**20-DDP-0047**  
**105 Rochester Dr**

**Louisville Metro Development Review Committee**

**Jay Lockett, AICP, Planner I**  
**October 14, 2020**

**BAE EXPANSION LANDSCAPE AND SCREENING EXHIBIT**

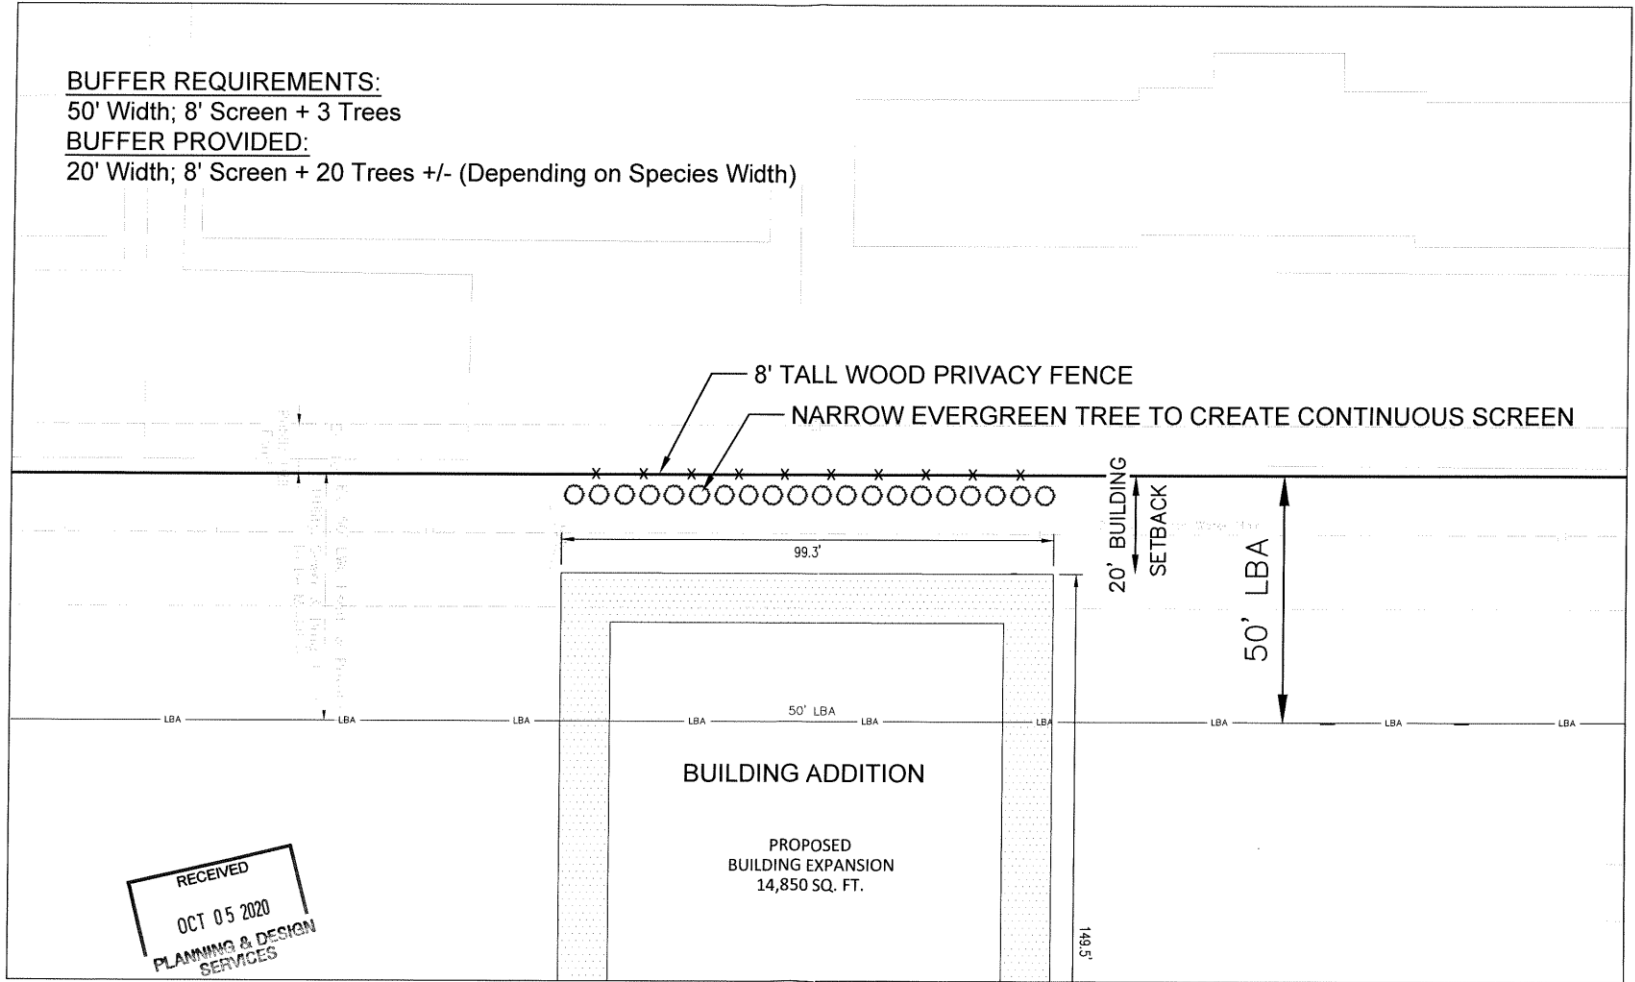
8. The applicant shall provide screening as shown on the landscaping exhibit presented to the Development Review Committee on October 14, 2020. The final location and type of trees shall be shown on the approved landscape plan and chosen in conference with Planning and Design Services staff landscape architect.
